**RE:     *SIR Comment Letter Response – Addendum #1***  
***Metacomet Redevelopment Project***  
***500 Veterans Memorial Parkway (Map 107, Plat 15, Lot 01)***  
***East Providence, Rhode Island***  
***RIDEM File No. SR-10-2243***  
***SAGE Project No. M1266***

## Attachment A – Site Redevelopment Plan

SHEET TITLE:  
**OVERALL SITE LAYOUT PLAN**  
 SHEET NUMBER:  
**C-301**  
 REVISION 3 - 11/01/2024

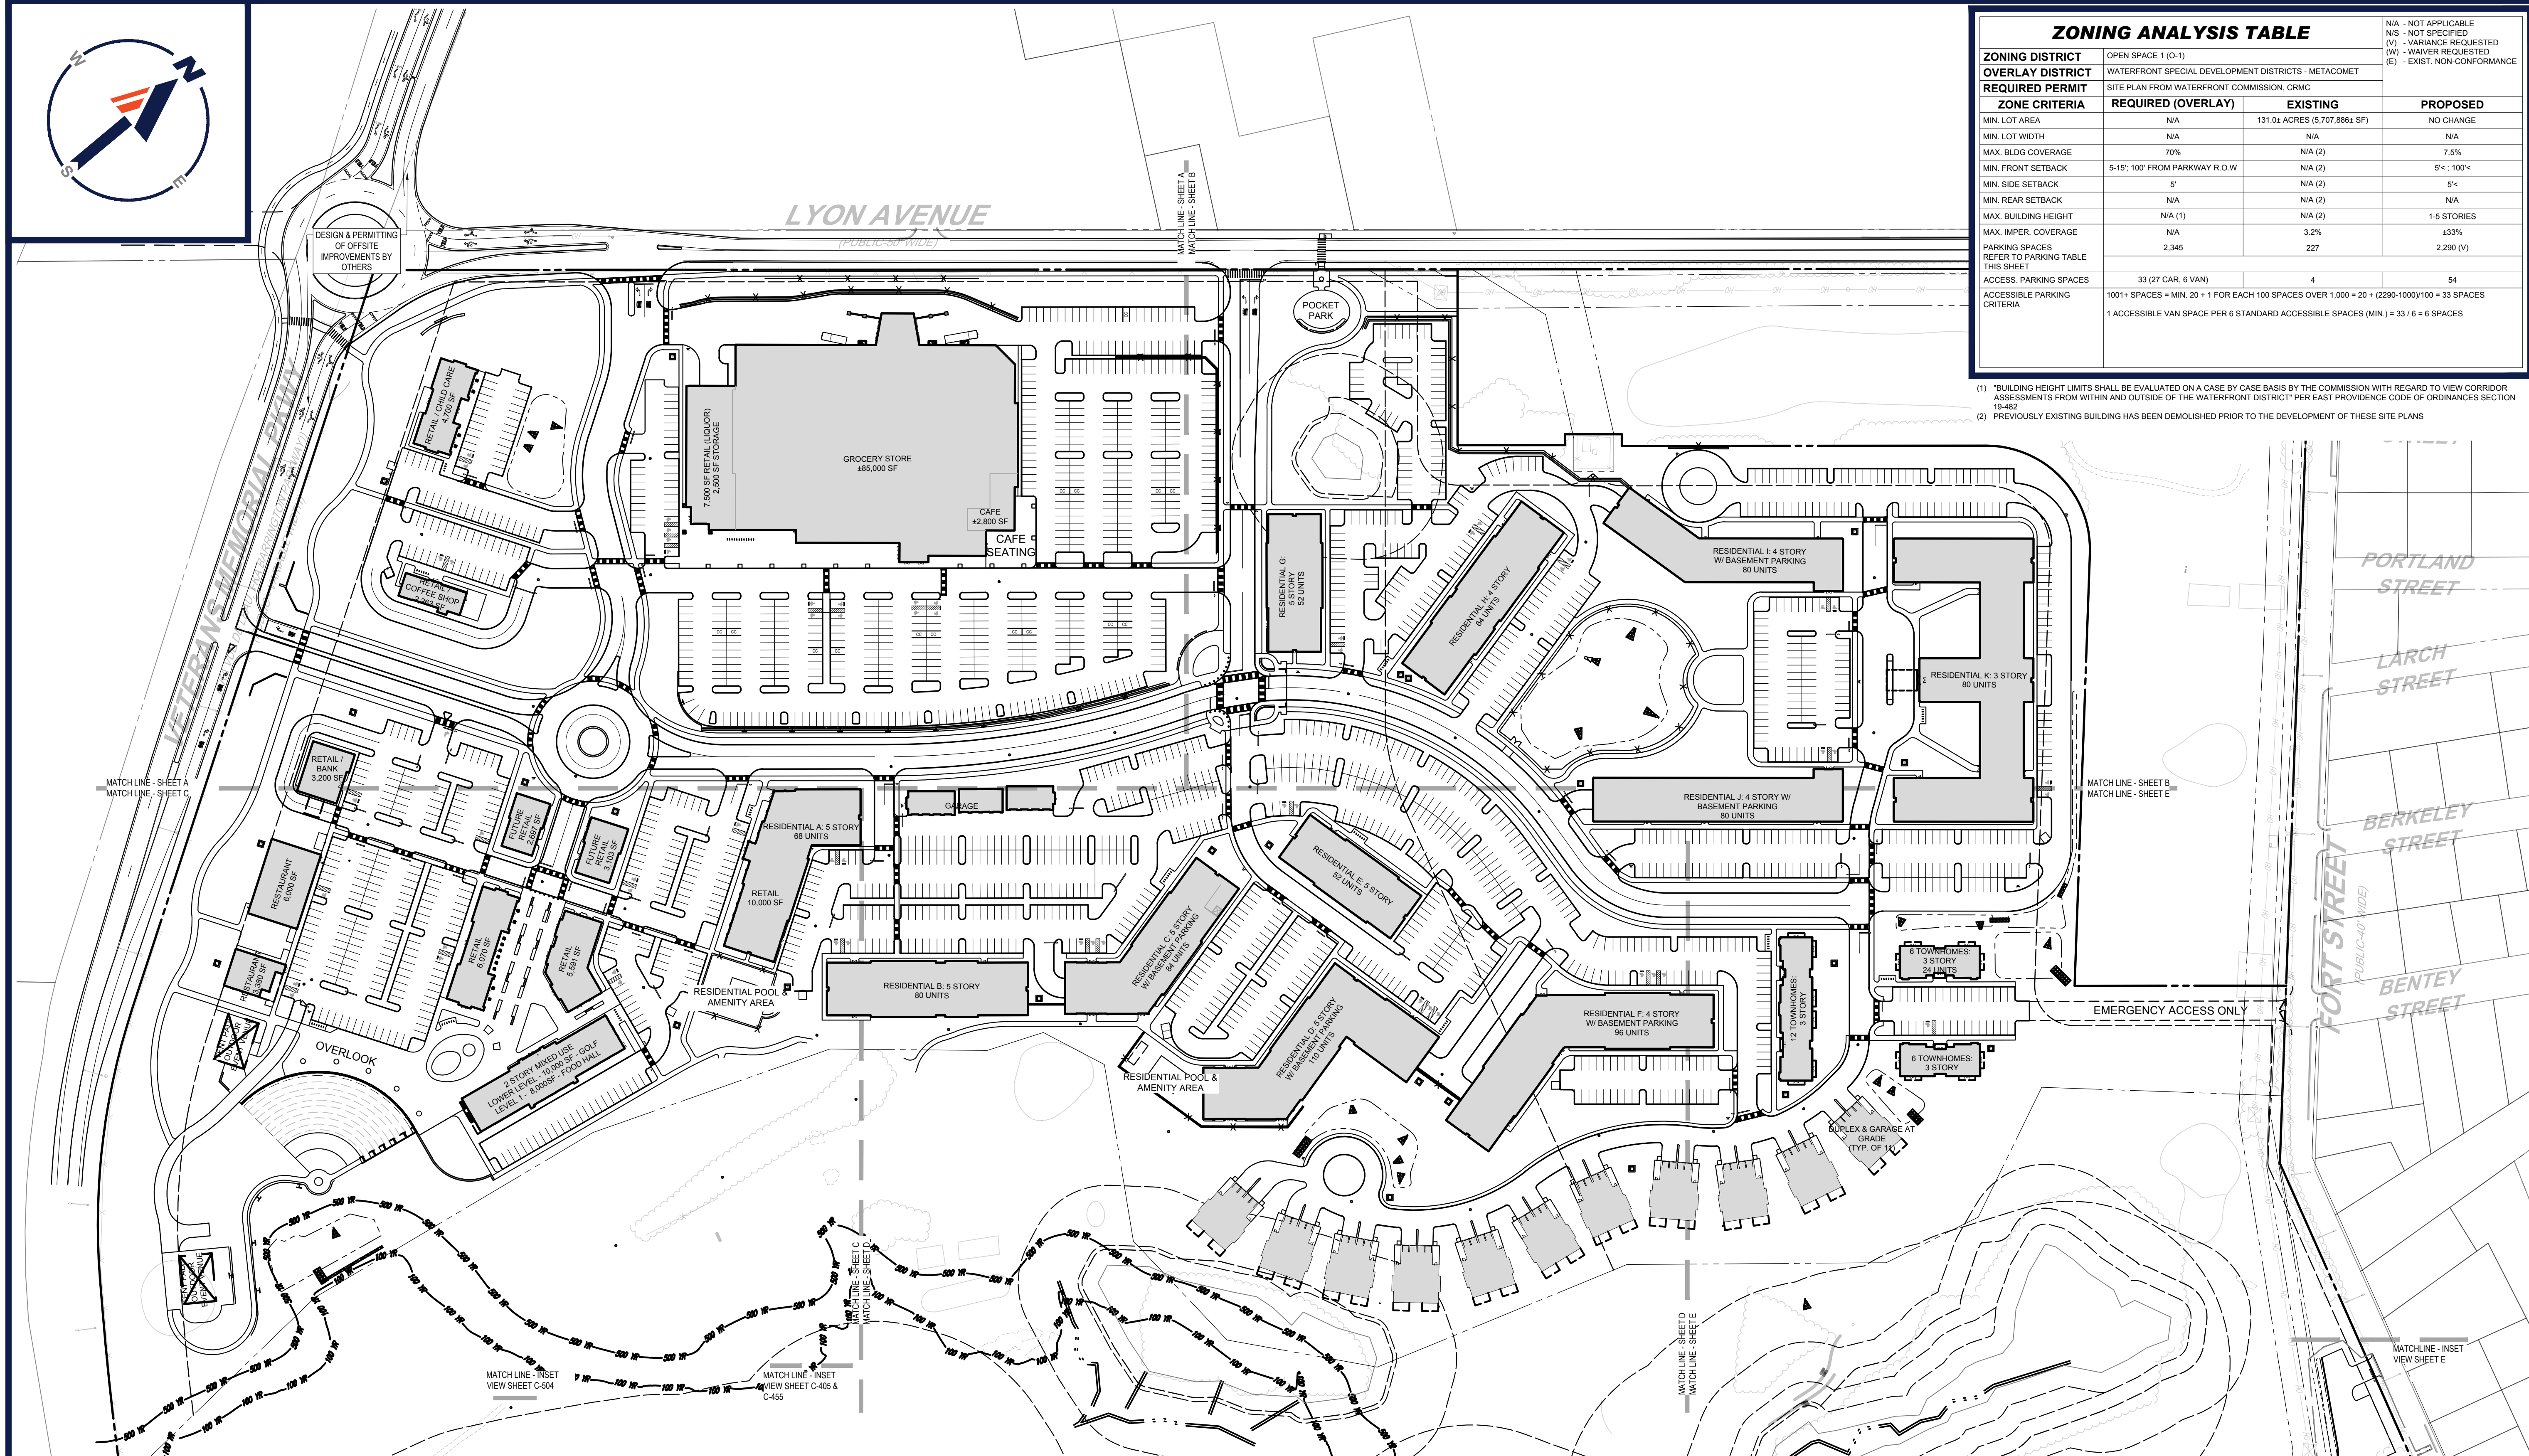
***Section 1.0 states that the site is planned to be redeveloped into a residential complex. However, Section 6.4 states that the site does not apply to Section 1.4(A)(68) of the Remediation Regulations, which defines “Residential Activity.” Please clarify if the site is planned to be redeveloped for residential use.***

As noted on the attached redevelopment plan, included here as **Attachment A**, a mix of future uses is planned for the subject property including residential owner-occupied units (i.e. town houses) as well as rental apartments and a variety of commercial uses.
